**SELF-IMPLEMENTING PROCEDURE COMPLETION REPORT  
UNDER 40 CFR 761.61(a),  
IMMEDIATE RESPONSE ACTION COMPLETION REPORT  
AND  
PERMANENT SOLUTION STATEMENT WITH CONDITIONS  
UNDER CMR 40.0000  
(No Activity and Use Limitation Required)**

**MA DEP RELEASE TRACKING NUMBER 2-19956  
FOR  
POLYCHLORINATED BIPHENYLS  
IN SOIL AND CONCRETE  
Site: 179 Brook Street  
Clinton, Massachusetts 01510**

**CJW Project No. 5812D**

**February 15, 2017**

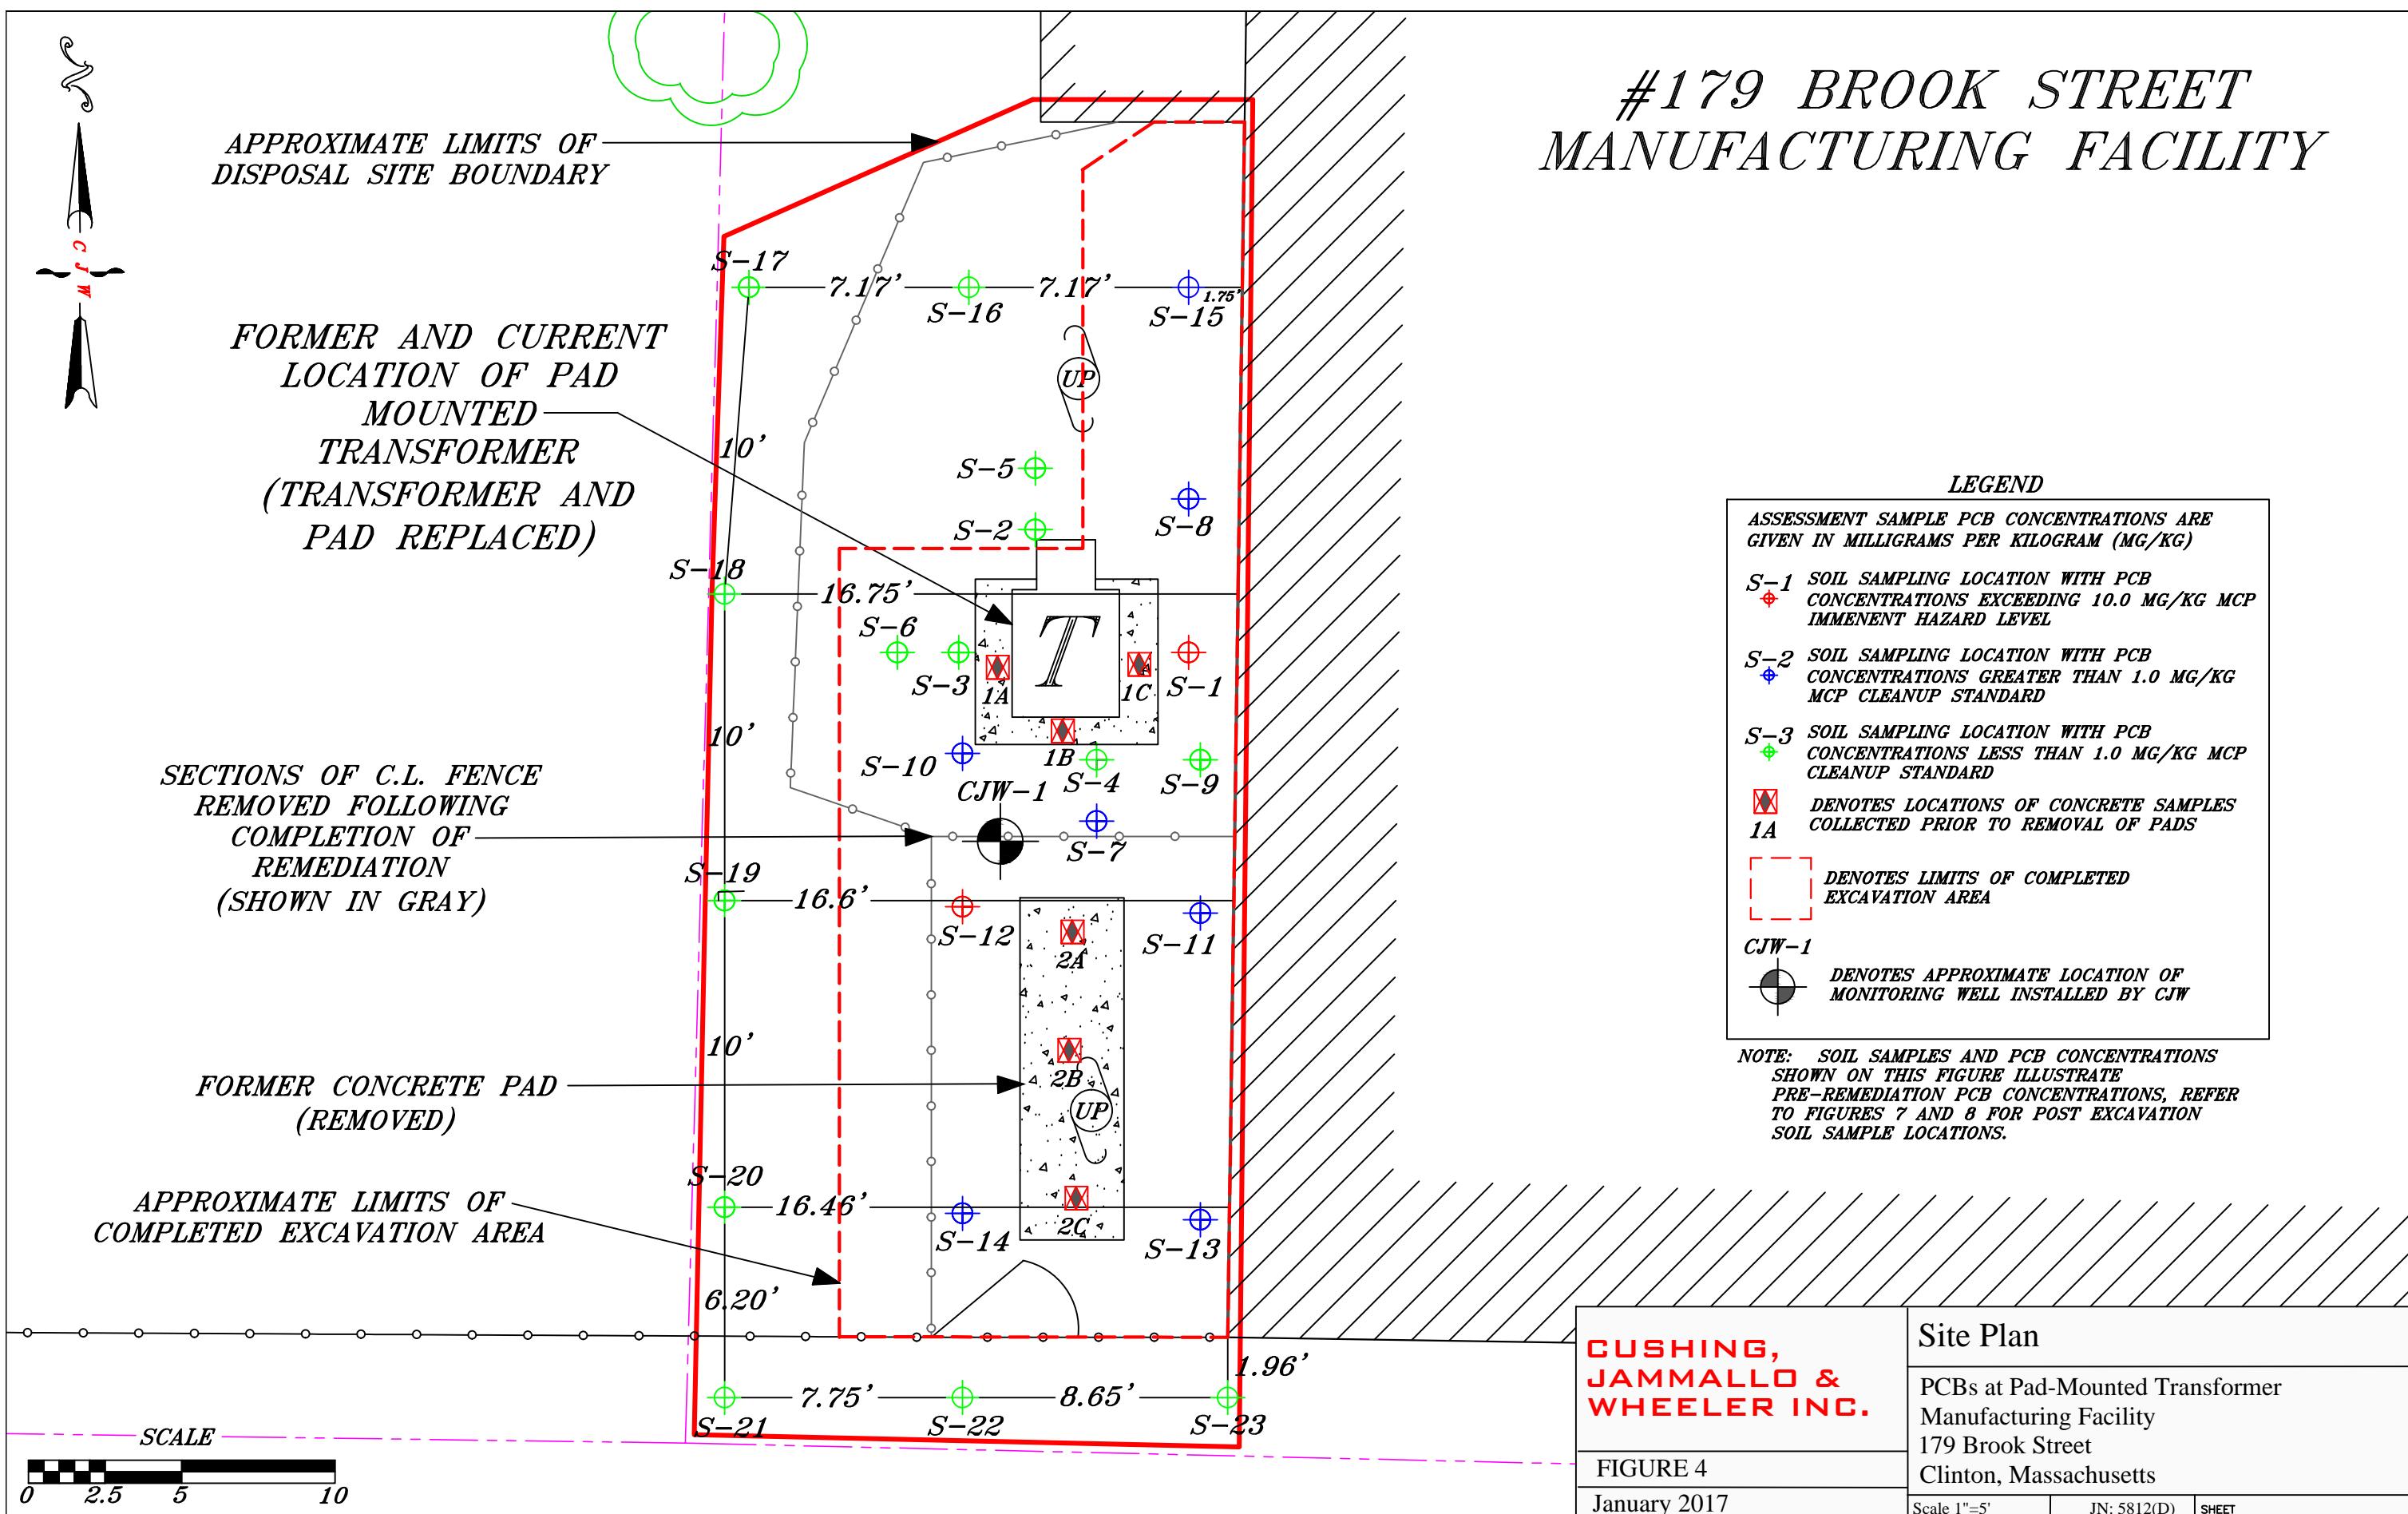
6. Page 13. Section 5.3.3. Paragraph 1. According to the text, the August 19, 2016 samples “were collected using a minimum grid interval of approximately 5 feet as shown on Figure 4.” However, the distance between samples shown on Figure 4 is generally 10 feet. Please review and correct the text/figure, as required for accuracy and consistency.

6. Page 13. Section 5.3.3. Paragraph 1. According to the text, the August 19, 2016 samples "were collected using a minimum grid interval of approximately 5 feet as shown on Figure 4." However, the distance between samples shown on Figure 4 is generally 10 feet. Please review and correct the text/figure, as required for accuracy and consistency.

Soil sampling from this date forward in the vicinity of the concrete pads was guided by 40 CFR 761, Subpart N, Cleanup Site Characterization Sampling for PCB Remediation Waste in Accordance with 761.61(a)(2). Subpart N specifies a sampling grid interval of 3 meters (approximately 9.84 feet). Soil samples discussed in this Section were collected using a maximum grid interval of approximately 10 feet as seen on Figure 4. More specifically, sample spacing ranged from approximately 5.7 (e.g. between samples S-13 and S-23) to approximately 10 feet (e.g. between samples S-12 and S-14; and S-11 and S-13). However, initial assessment soil samples collected in the immediately vicinity of the pad-mounted transformer (e.g. samples S-5, S-2 and S-6, S-3 and S-3, S-10 and S-10, S-4 and S-4, S-7, S-9) were done so at closer intervals in an effort to confirm the likely source of the PCB release. See Sections 5.3.2 and 5.3.3).

## Monitoring Well Location Plan

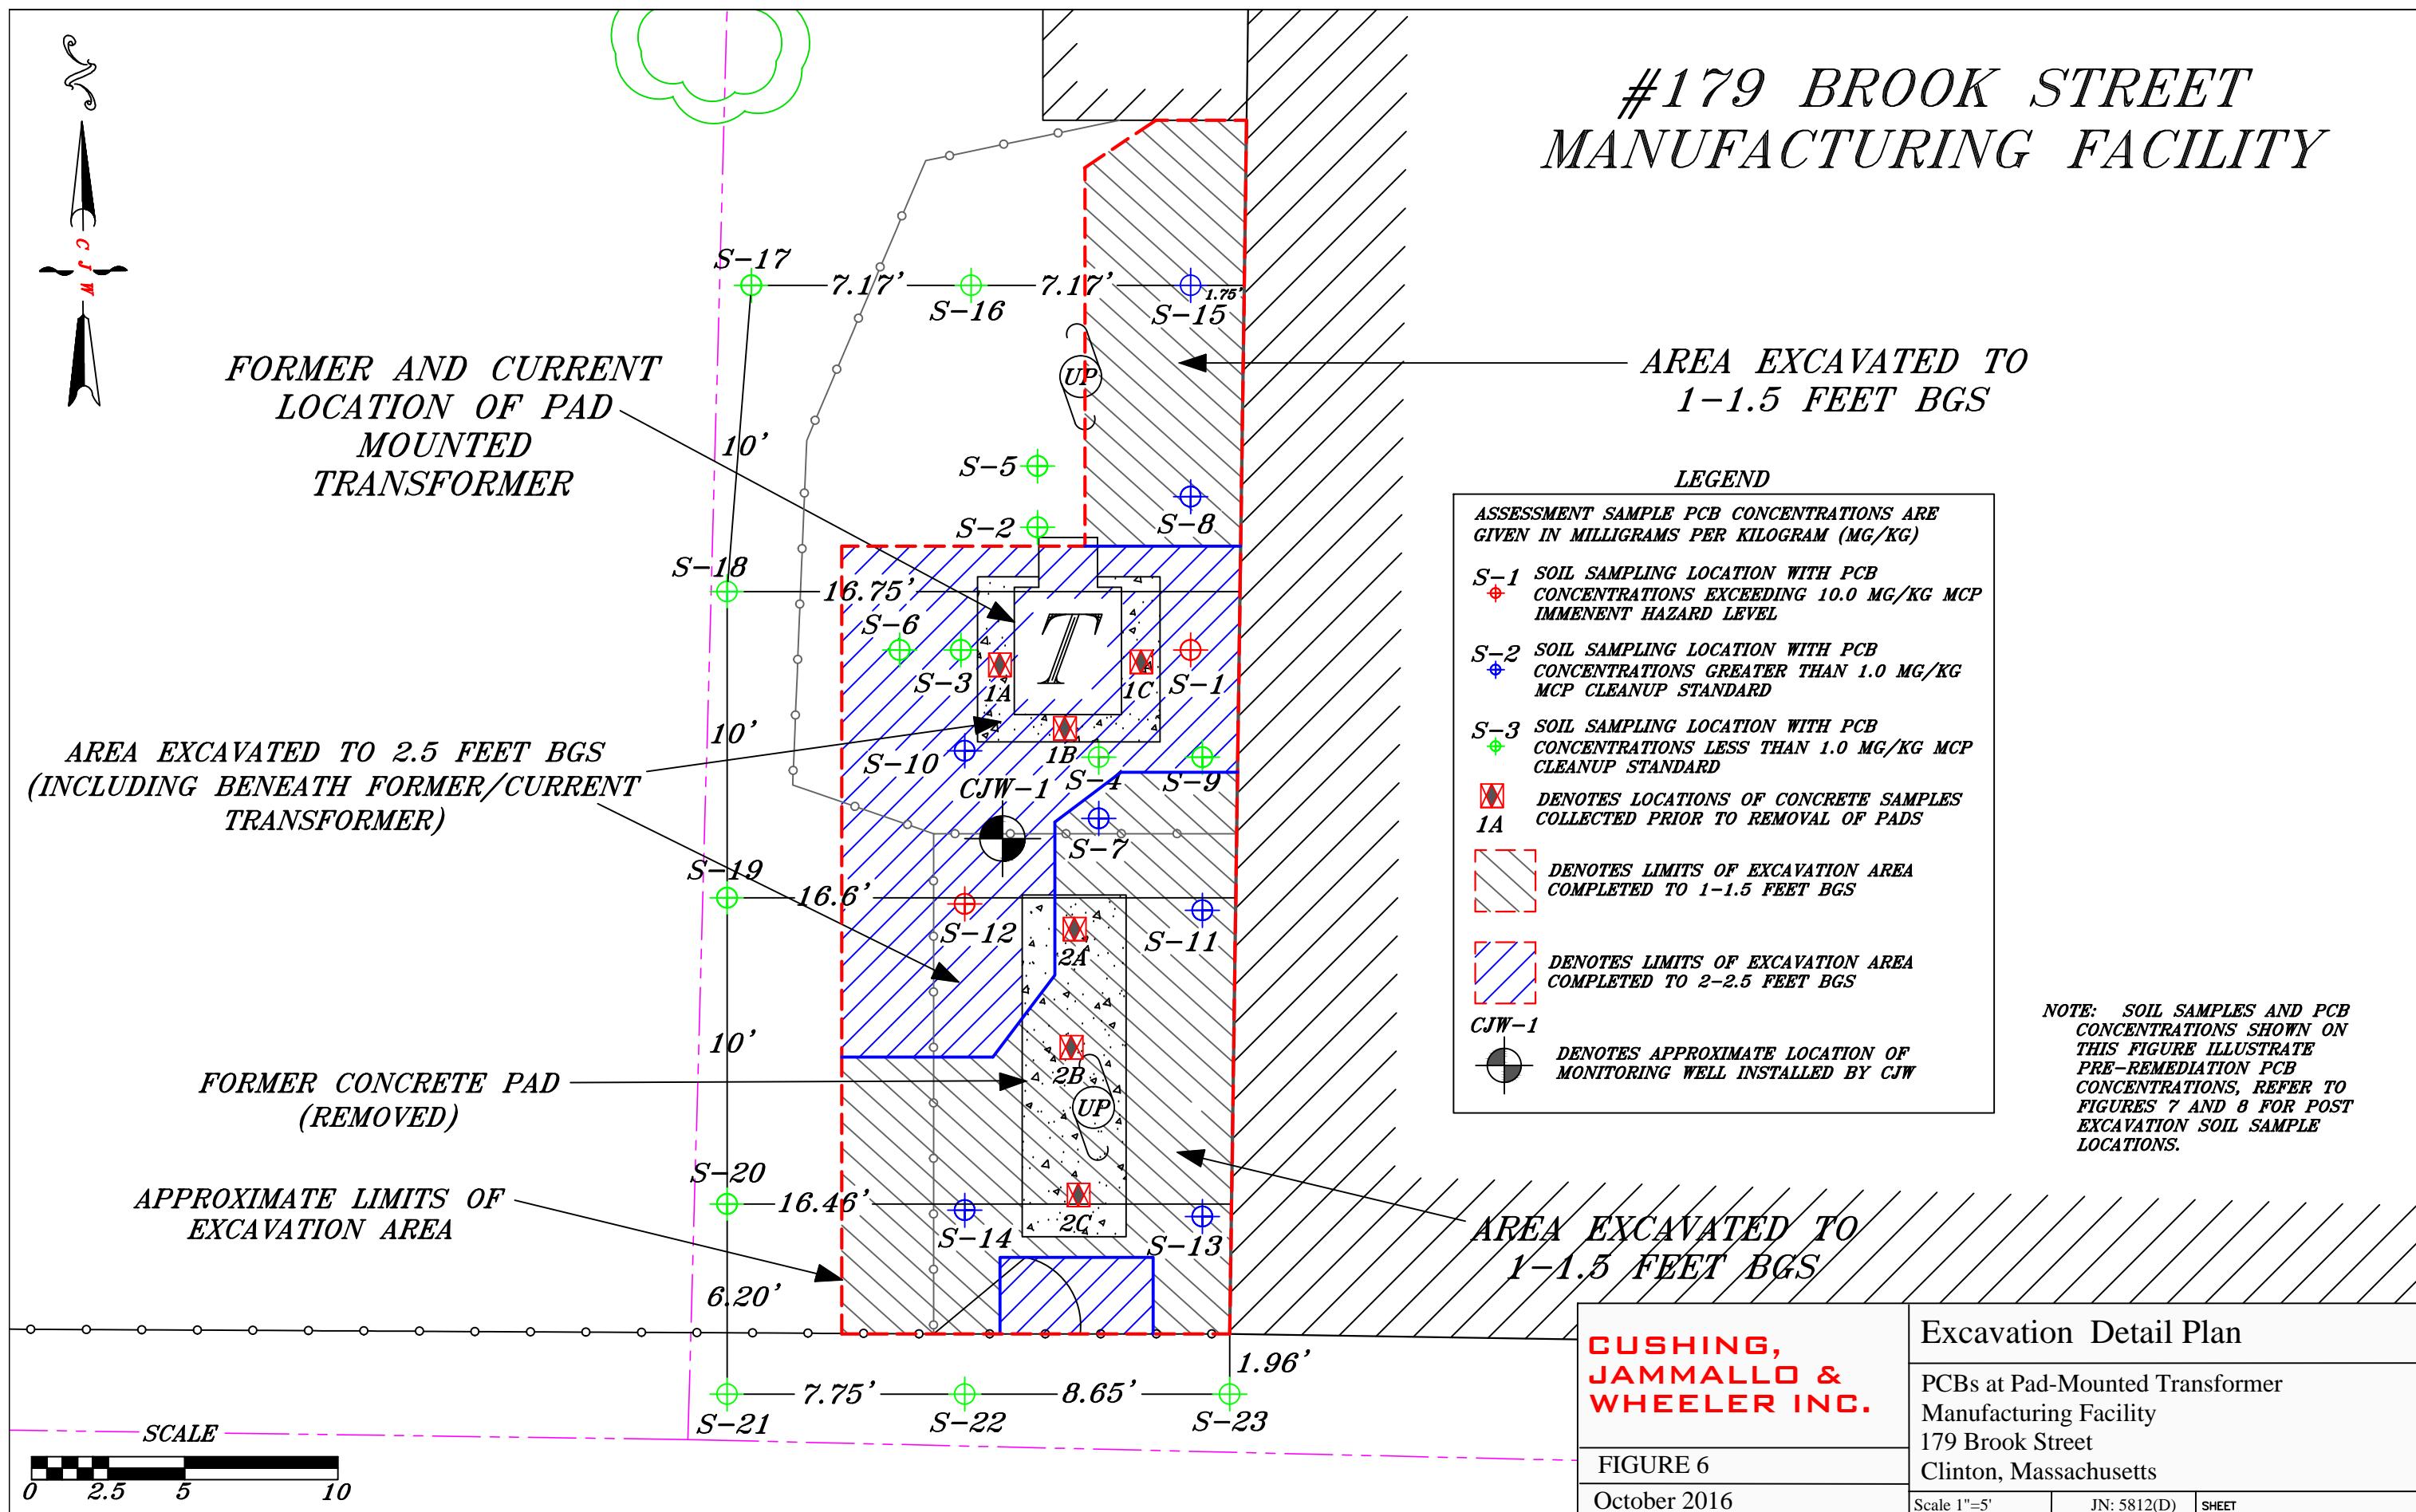
- a. It is unclear what is meant by “this exterior area”. Please provide additional discussion that clarifies this statement.
  - b. Please provide a drawing that identifies the location of the monitoring wells.

*Three additional pole-mounted transformer are currently located exterior to the building and approximately 92 feet north of the pad-mounted transformer which has been shown to contain transformer oil containing 110 ppm of PCBs. See Section 1.2.1 and Figure 5 in the revised SIP Plan.*

*The phrase "this exterior area" simply refers to the area at and in the immediate vicinity of the pad-mounted transformer that is located adjacent to the western exterior of the building and which has been shown to contain transformer oil containing 110 ppm of PCBs. See Figure 5 in the revised SIP Plan which shows the location of monitoring well at 179 Brook Street. See Section 4.0 in the revised SIP Plan for a discussion of the depth to groundwater in monitoring wells at 179 Brook Street and the expected depth to groundwater expected in the immediate vicinity of the pad-mounted transformer that has been shown to contain transformer oil containing 110 ppm of PCBs. See Figure 5 – Monitoring Well Location Plan and Table 2 – Summary of Groundwater Gauging Data in the revised SIP Plan.*
